**SITE PLAN REVIEW SHEET
ENVIRONMENTAL VARIANCE REQUEST ONLY**

CASE: SP-2019-0027CT

PROJECT NAME: 1514 W Koenig Lane Office Building

Re: Environmental variance requests for 1514 W. Koenig Lane Office Building, Austin, Texas 78756
Case: SP-2019-0027C

Figure 2. Photos of Hancock Branch at Arroyo Seco and Koenig Lane

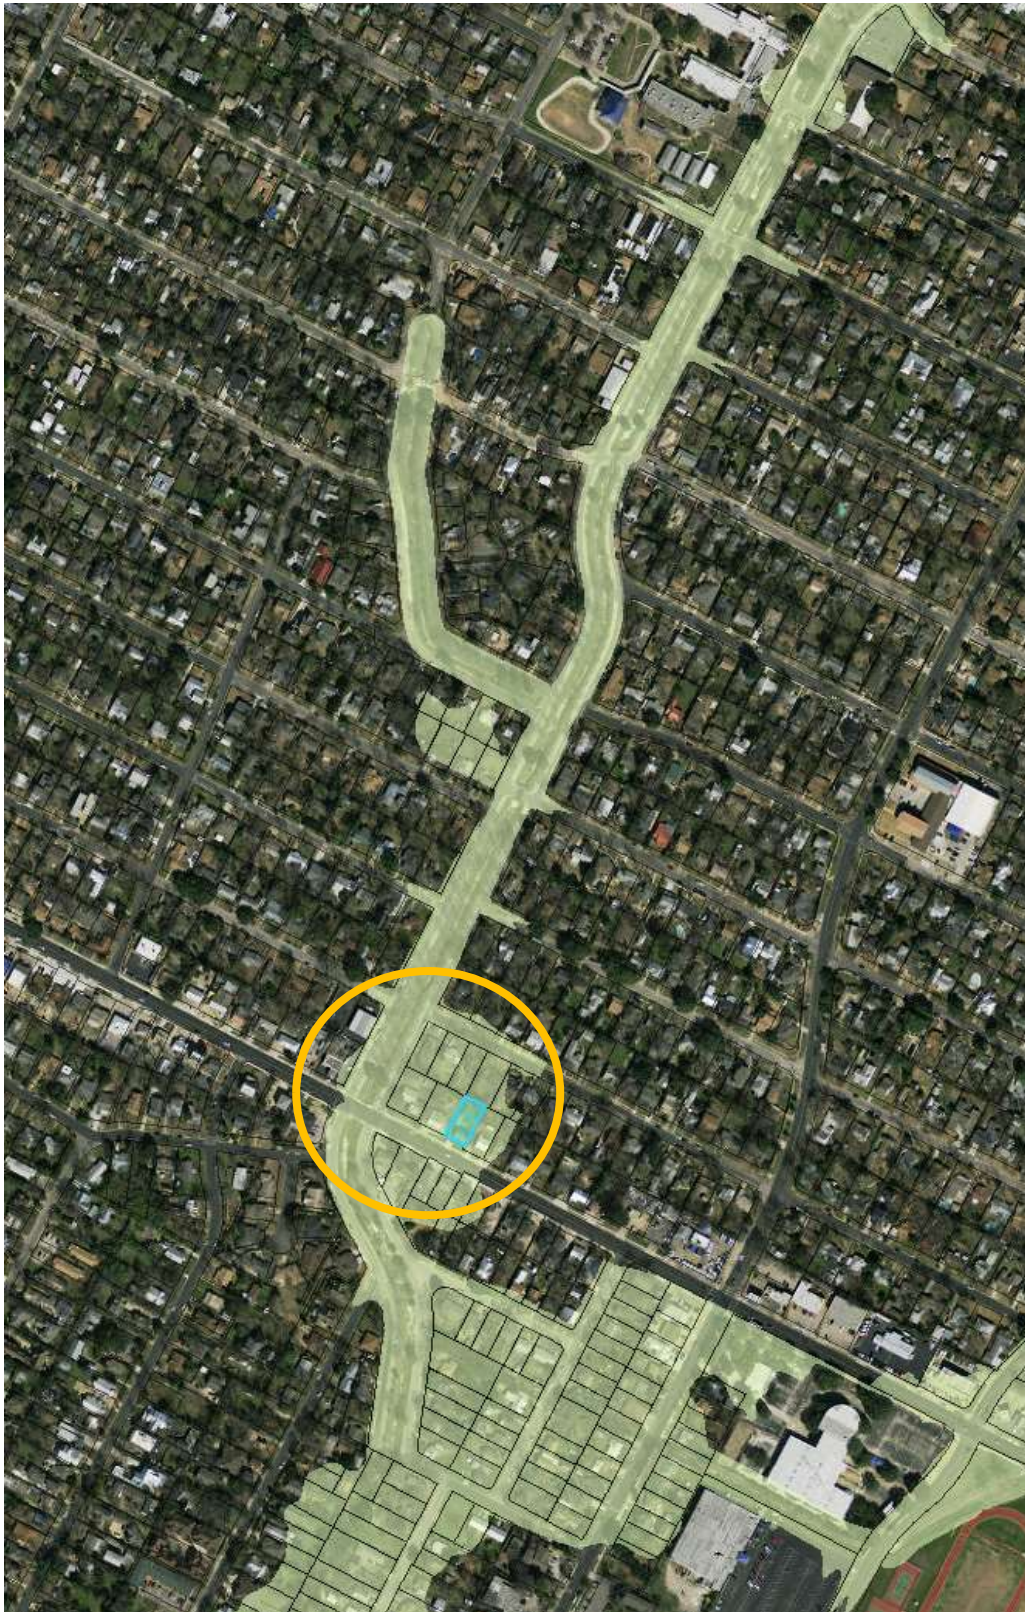
Figure 2 shows photos of the creek consisting mostly of vegetation that is periodically mowed down for maintenance. There are no plans to remove Koenig Lane, Palo Duro Canyon, and Arroyo Seco roadways and the existing commercial and residential impervious cover to restore the CWQZ to a natural condition.

CRITICAL WATER QUALITY ZONE

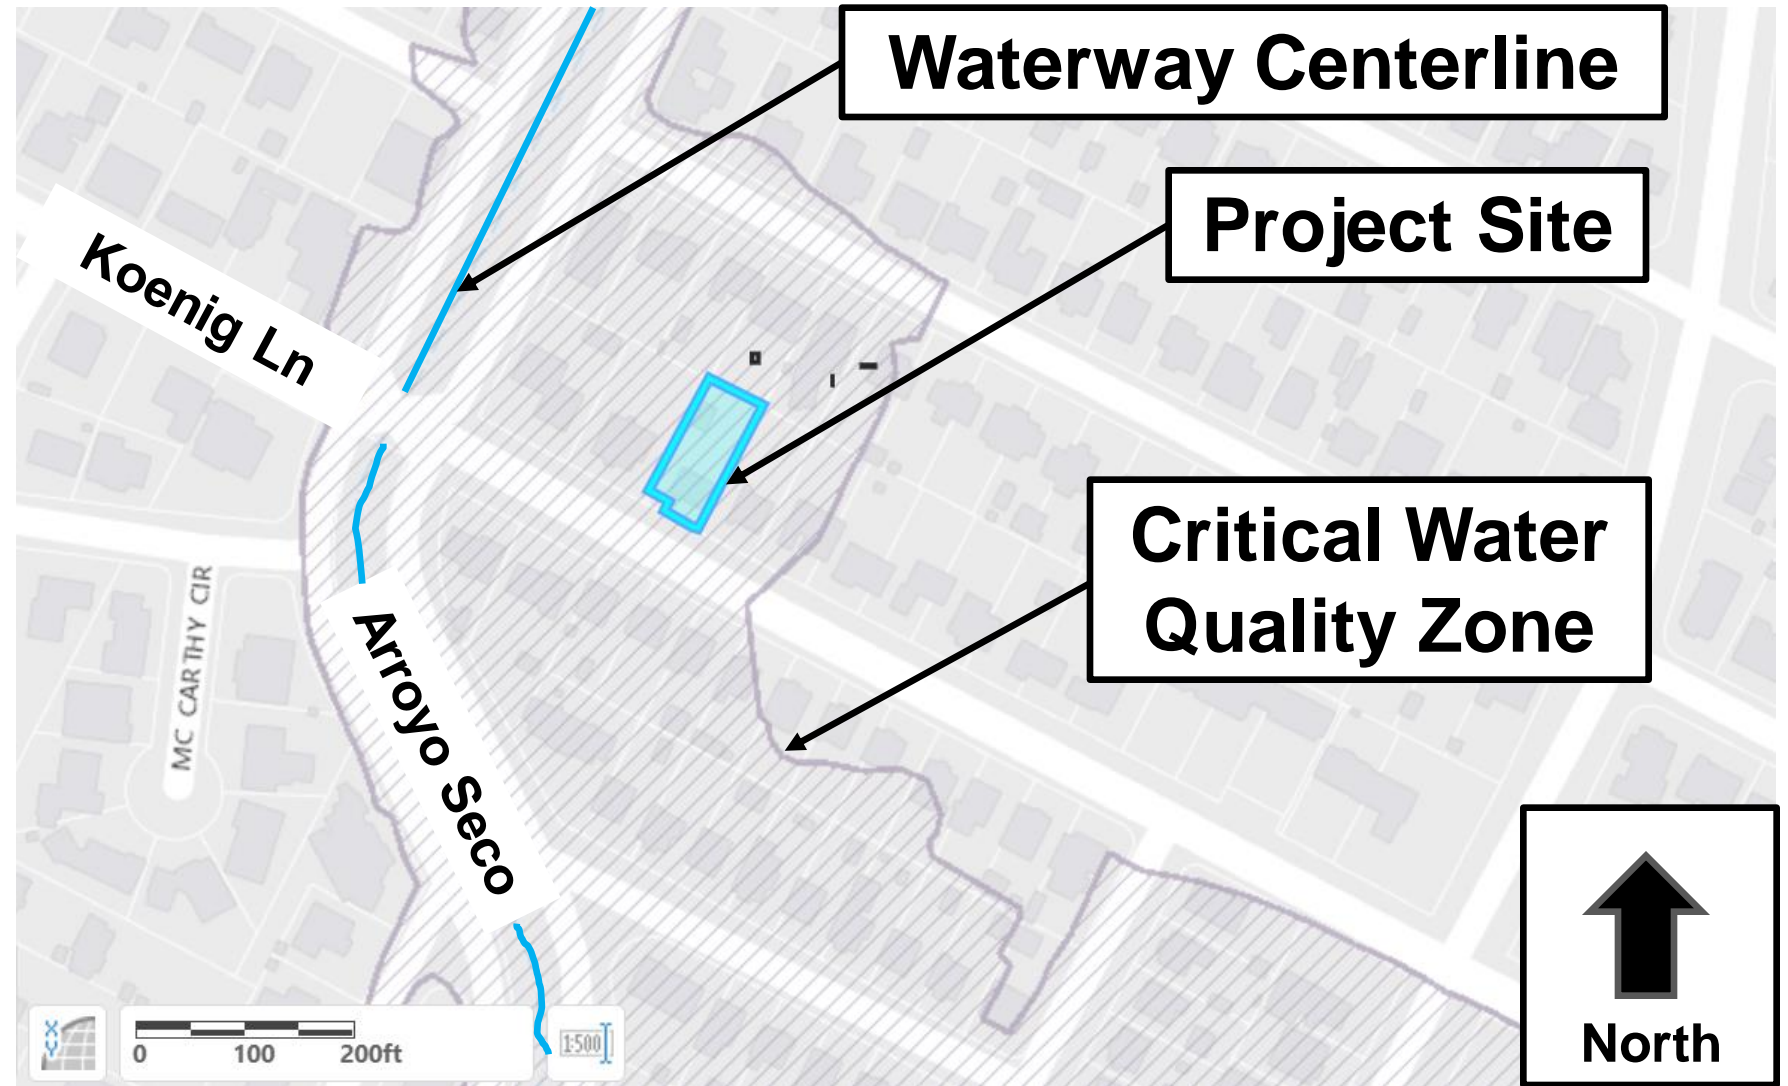
The entire property is located within the Critical Water Quality Zone.

B-17 FULLY DEVELOPED FLOODPLAINS

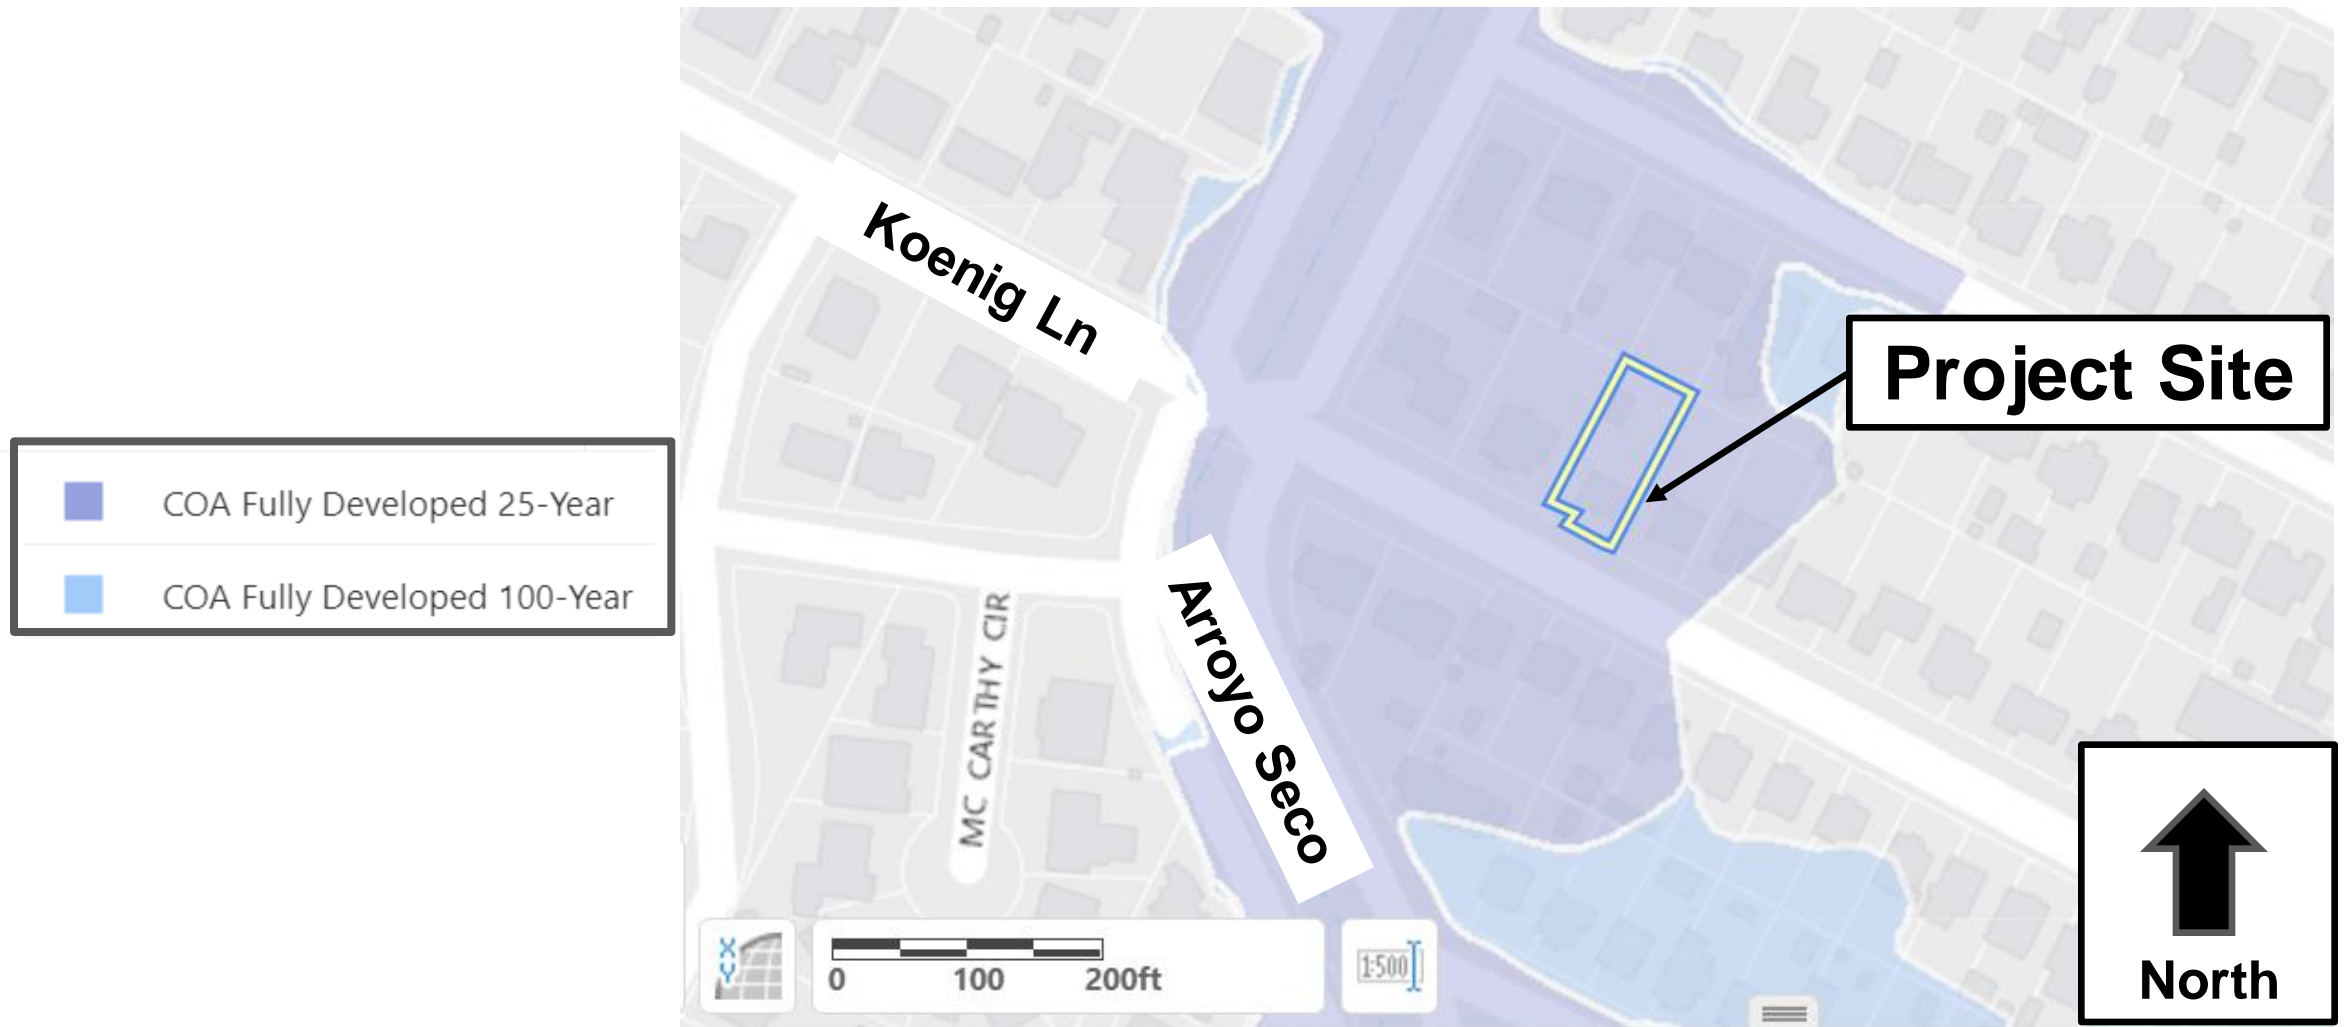
The entire property is located within the fully developed 25 year floodplain and within the fully developed 100 year floodplain.
